Access Compliance Report

Public Rights-of-Way

Intersection ID: 3180	Main Street: JOHNSTON_OEHLER_RD	Cross Street: SONG_SPARROW_LN	Location:	W
ADA ID: 6B19C53B3319	Ramp Type: Perp	Initial Pass/Fail: Fail	Overall Compliance: No	Severity Score: 25
Codes/Mitigation Info/Possible Solution		Field Measurements/Component Compliance

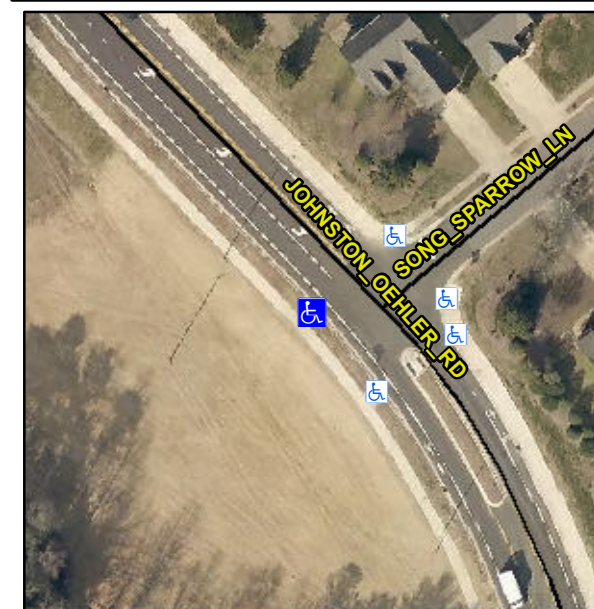
Compliance	Description	Data	Compliance	Description	Data
N/A	Ramp Length (in)	96.0	No	Ramp Slope (%)	13.0
Yes	Ramp Width (in)	95.0	Yes	Ramp XSlope (%)	1.8
N/A	Flare Type LT	N/A	N/A	Flare Type RT	N/A
N/A	Flare Slope LT (%)	N/A	N/A	Flare Slope RT (%)	N/A
N/A	Flare Traversable LT?	N/A	N/A	Flare Traversable RT?	N/A
N/A	Landing Length (in)	N/A	N/A	DWS Provided?	N/A
N/A	Landing Width (in)	N/A	N/A	DWS Contrast?	N/A
N/A	Landing Slope (%)	N/A	N/A	DWS Length (in)	N/A
N/A	Landing X Slope (%)	N/A	N/A	DWS Full Width?	N/A
N/A	Landing Curb? (Y/N)	N/A	N/A	DWS Offset (in)	N/A
N/A	Shared Landing?	N/A			
N/A	Gutter Ponding?	N/A	N/A	Gutter Slope (%)	N/A
N/A	Gutter Lip Ht (in)	N/A	N/A	Gutter X Slope (%)	N/A
N/A	Painted X Walk1?	No	N/A	Painted X Walk2?	N/A
	X Walk 1 Direction	To NE		X Walk 2 Direction	N/A
N/A	X Walk 1 Width (in)	N/A	N/A	X Walk 2 Width (in)	N/A
	X Walk 1 Slope (%)	1.1		X Walk 2 Slope (%)	N/A
	X Walk 1 X Slope (%)	2.3		X Walk 2 X Slope (%)	N/A

Remove & Replace Entire Ramp.
